AMENDMENTS TO THE DRAWINGS:

REMARKS

10/660,754 DOCKET NO. K06-161131M/TBS

F/G. 3

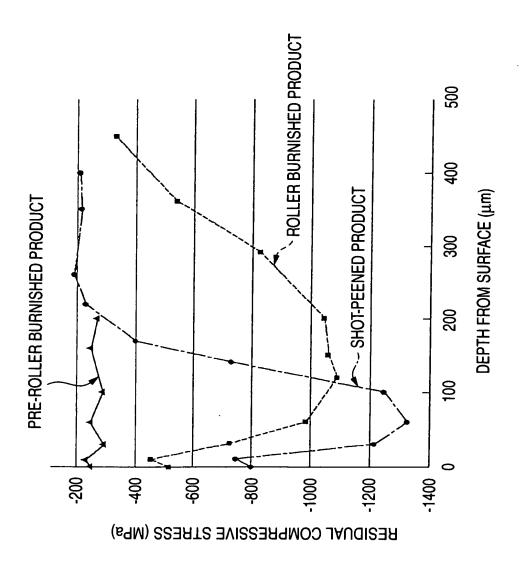
The Office Action objects to Figure 3 because that figure "does not make sense." In this regard, Applicants thank Examiner Binda for the courtesies extended during a telephone conference on February 21, 2006, where Examiner Binda explained his concerns regarding Figure 3.

The Examiner also objected to Figure 3 for not showing a residual compressive stress as being larger than 800 MPa at depths of at least 0.3 mm as described by the specification at page 11, lines 8+ and page 12, lines 22+. In this regard, this Amendment amends the specification to more clearly describe that the residual compressive stress is larger than 800 MPa at a depth of up to 0.3 mm. Applicants respectfully request withdrawal of this objection.

The attached sheet of drawings includes changes to Figure 3. This sheet, which includes Figure 3, replaces the original sheet including Figure 3. In Figure 3, the graph has been corrected to correspond with common graph conventions in accordance with Examiner Binda's very helpful suggestions.

In response to Examiner Binda's very helpful suggestions, this Amendment encloses a replacement drawing sheet which corrects Figure 3 to comply with recognized conventions regarding representing a residual compressive stress which increases as corresponding to an increase in the distance along the Y- axis from the origin, to provide the legends for the X-axis along the X-axis, and to correctly show the X-axis as extending from the origin of the graph. Applicants respectfully request withdrawal of this objection.

Corrections have been made per Examiner's Suggestions,
